STATE OF WASHINGTON
DEPARTMENT OF ECOLOGY

M E M O R A N D U M

To: Darrel Anderson, Southwest Regional Office
From: Dale Clark ^{Dkc}
Subject: Seashore Villa Wastewater Treatment Plant Limited Class II Inspection, July 1-2, 1985

Figure 2. Flow scheme and sampling locations - Seashore Villa, July 1985.

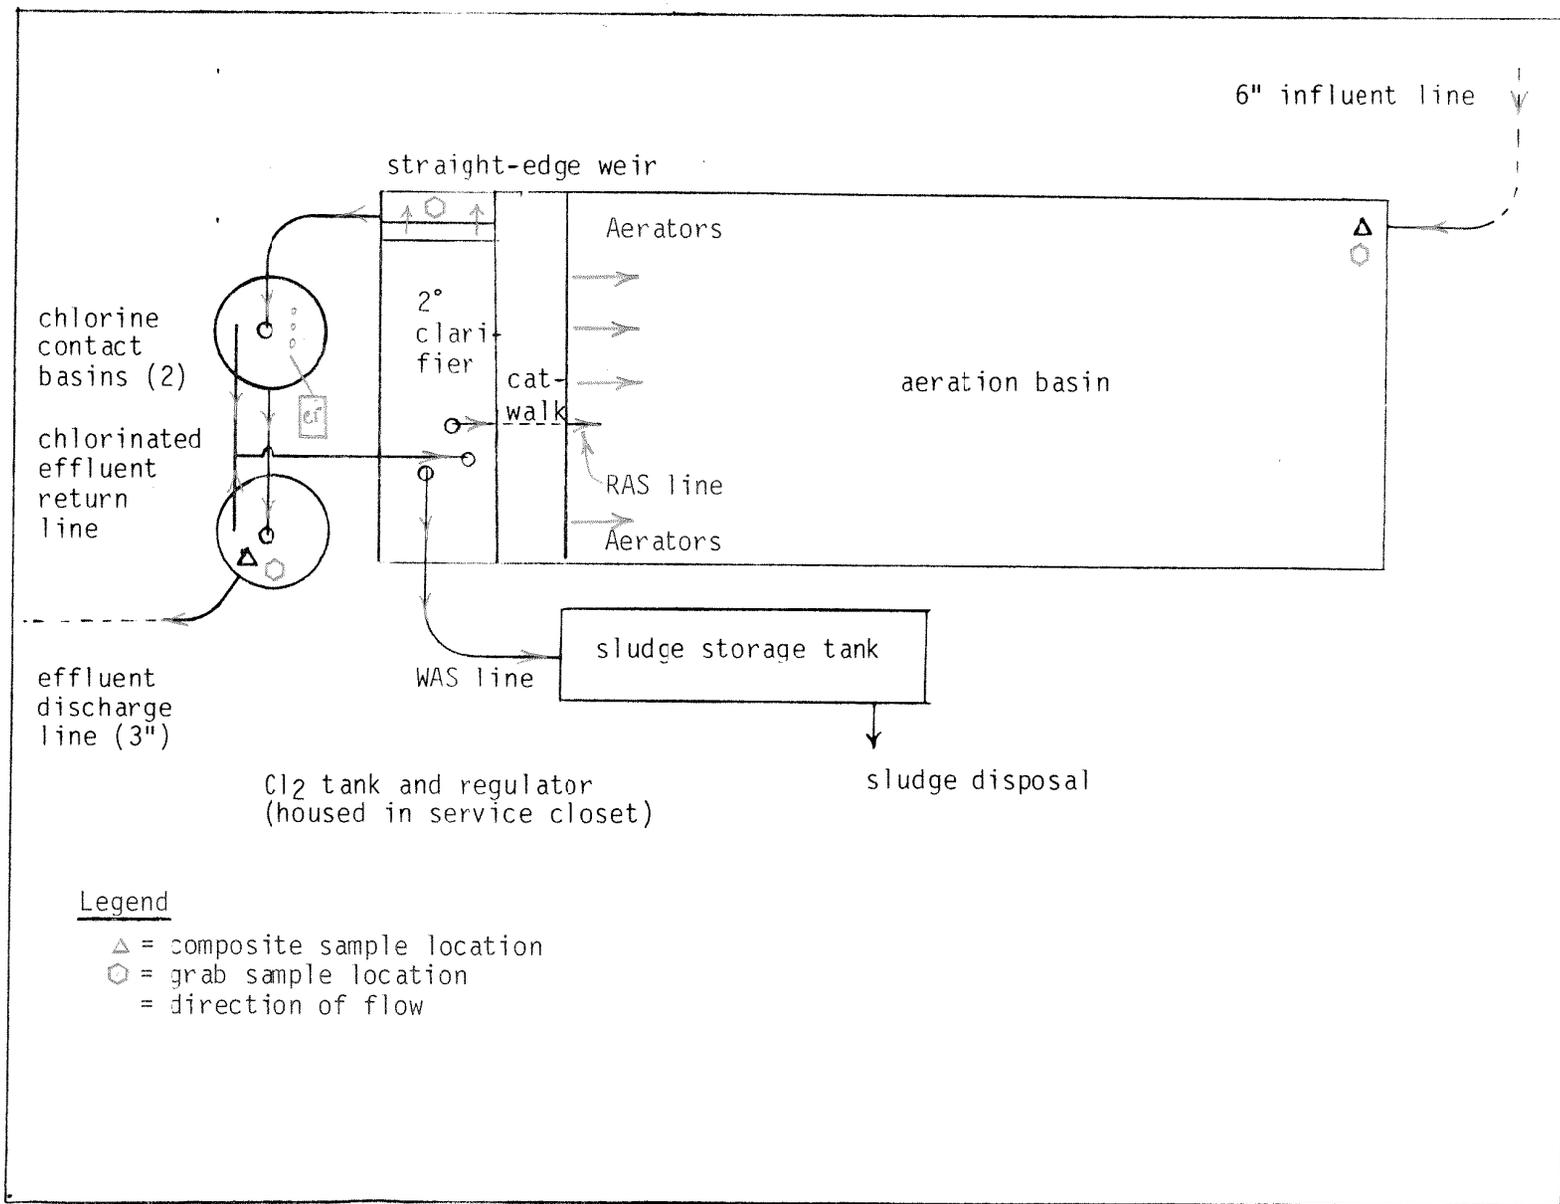
1. A three-inch return line from chlorine contact chamber #1 was recycling chlorinated effluent to the secondary clarifier.
2. High effluent solids concentrations were resulting from solids washout of the secondary clarifier.

Prior to the inspection, a return line from the chlorine contact chamber #1 was left open, allowing chlorinated effluent to recycle into the secondary clarifier and eventually back to the aeration basin via the RAS line. The clarifier was tested for total residual chlorine. During aeration, 0.15 mg/L was detected, while none was detected when the aerators were off. The return may have had a negative impact on the plant's biological population. It is recommended that recycle of chlorinated effluent be prevented.

The high effluent solids concentration appeared to be related to operating characteristics of the aeration system. The aerator operated on a 45-minutes-on, 15-minutes-off cycle, with the RAS pumps operating during the "on" portion of the cycle. During the "on" cycle, mixed liquor in the aeration basin rose by approximately four inches. When the aerators stopped, the excess water in the basin (estimated at 670 gallons) surged into the secondary clarifier. Effluent grab samples taken during periods of surging had TSS values of 340

1. Correct surging in the aeration basin. The surging has resulted in a solids washout problem. The problem is probably a key factor contributing to low MLSS in the aeration basin and effluent exceeding the NPDES permit limit for BOD₅ and total suspended solids.
2. Discontinue the chlorinated effluent recycle from chlorine contact basin (#1) to the secondary clarifier.
3. Increase solids concentration (MLSS) in the aeration basin to improve biological treatment and reduce effluent BOD₅.
4. Measure flows in the WTP effluent line and the DNR influent line.
